UNITED STATES PATENT AND TRADEMARK OFFICE

APPLICATION NO.	FILING DATE	FIRST NAMED INVENTOR	ATTORNEY DOCKET NO.	CONFIRMATION NO.
10/772,629	02/04/2004	Myan Spaccarelli	7294-101	5652
167	7590	04/27/2006	EXAMINER	
FULBRIGHT AND JAWORSKI LLP 555 S. FLOWER STREET, 41ST FLOOR LOS ANGELES, CA 90071			KIM, SANG K	
			ART UNIT	PAPER NUMBER
			3654

Office Action Summary	Application No.	Applicant(s)	
	10/772,629	SPACCARELLI ET AL.	
	Examiner	Art Unit	
	SANG KIM	3654

FIG . 6

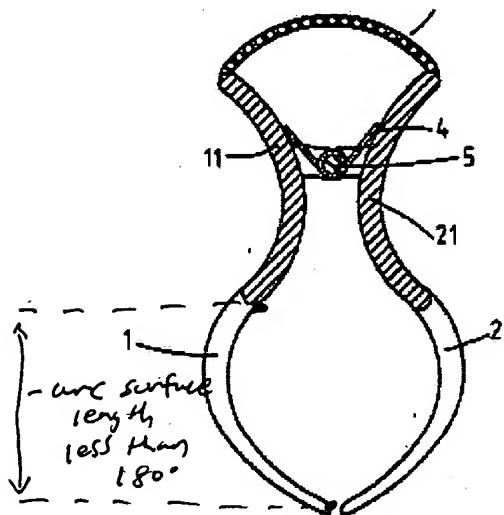
With respect to claims 7 and 12, each arcuate surface has an arc length of less than 180 degrees is inherently taught by Lee '096 since each arcuate surface measured from one end to the other end does not extend more than 180 degrees, see figure 6 below.
